**Subject: Docket Nos. 50-361 and 50-362
Additional Information Supporting the Third Ten-Year Inservice
Inspection (ISI) Interval Relief Requests ISI-3-11, Revision 1 and
ISI-3-12 to Support Pressurizer Heater Sleeve Repairs
San Onofre Nuclear Generating Station, Units 2 and 3**

**SOUTHERN CALIFORNIA EDISON
RESPONSE TO NRC STAFF
REQUEST FOR ADDITIONAL INFORMATION
SUPPORTING RELIEF REQUESTS ISI-3-11 AND ISI-3-12
PRESSURIZER HEATER SLEEVE REPAIR
SAN ONOFRE NUCLEAR GENERATING STATION UNITS 2 AND 3**

Figure 4-2 — Postulated BWC in Nozzle Repair Region.

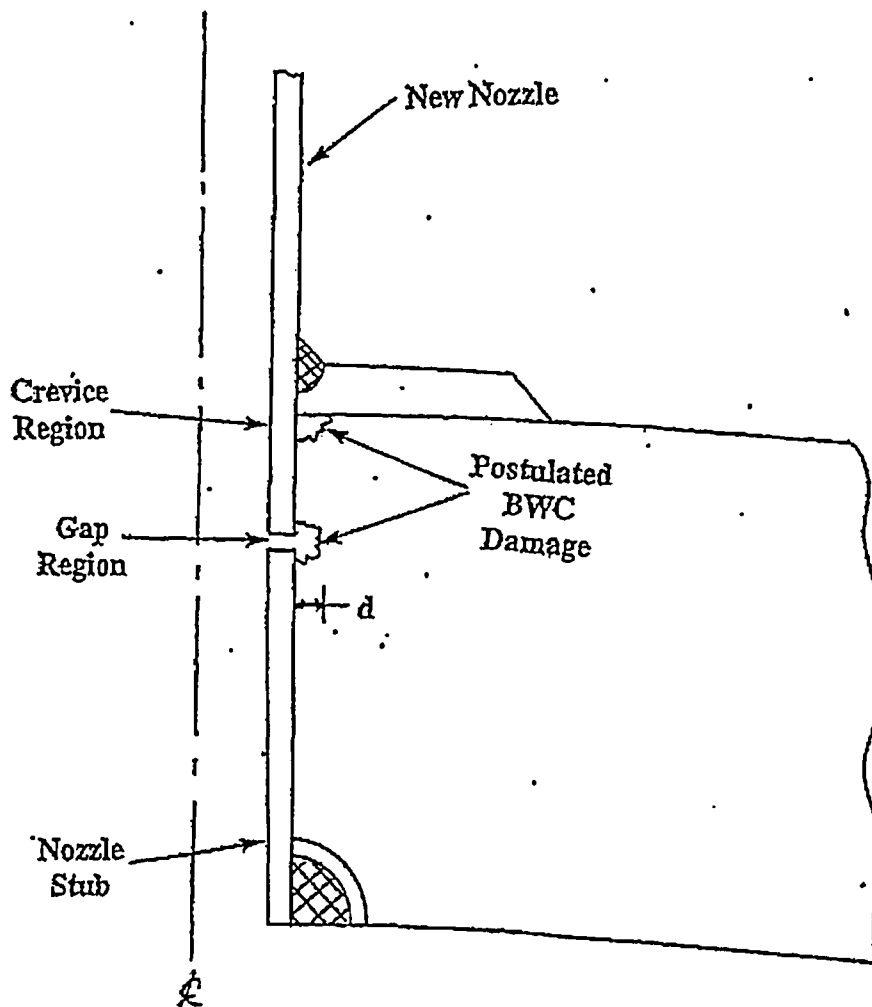
Section 2.3 "Borated Water Corrosion Evaluation," (pages 12 and 13) and Figure 4-2 "Postulated BWC in Nozzle Repair Region" (page 27) from Aptech Engineering Services calculation No. AES-C-3724-1 (Reference 5) are provided in Attachment 3.

The potential BWC of the low alloy steel head/shell material was conservatively evaluated. Local corrosion was modeled as a circumferential planar groove within the hole penetration. The postulated corrosion damage is shown in Figure 4-2. The integrity of the nozzle attachment was determined as a function of location of BWC within the hole, and depth and length of the corrosion groove. A limit load-based evaluation (including fatigue crack growth) was completed following the general approach of ASME Section XI, Appendix H, for flaws in ferritic piping. The allowable corrosion depths and lengths were established based on maintaining a minimum safety factor of 2.77 for normal and upset service conditions and 1.39 for accident conditions.
